Motion Consultants – Technical Note for Highways and Transport Issues raised at the Stage 3 Hearings in June and July

Site: TWBC Local Plan EIP
Prepared by: John Russell, BEng (Hons), CMILT, MIHT, DipTP
Date: 4th October 2024

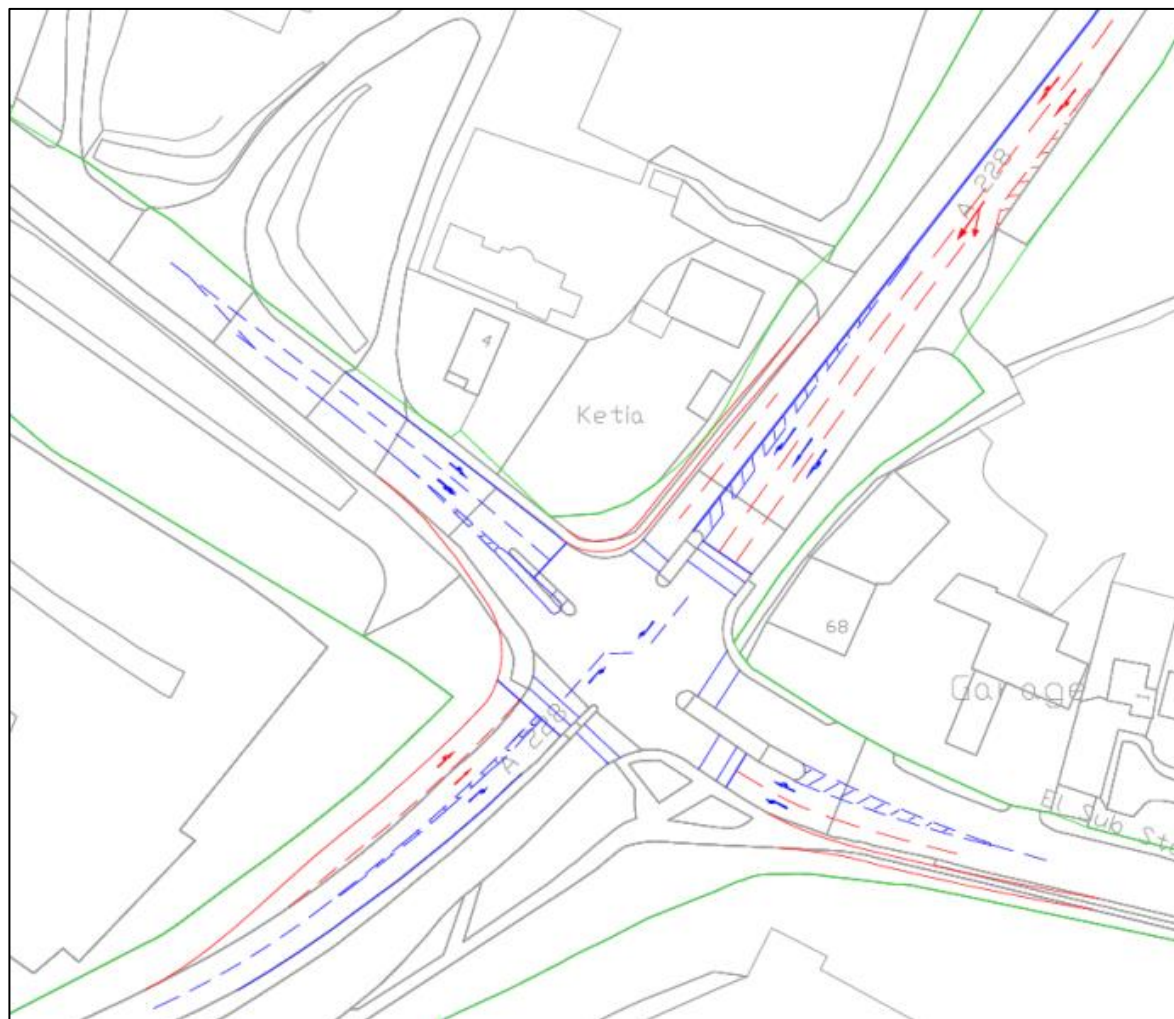
- 3.1 This document is entirely new evidence submitted to the EIP in July 2024. Indeed, since TWBC’s Consultations began in 2019 this is the first time that any reference to traffic issues in the Pembury Road Corridor, five years later, and almost three years after the Submission Local Plan.
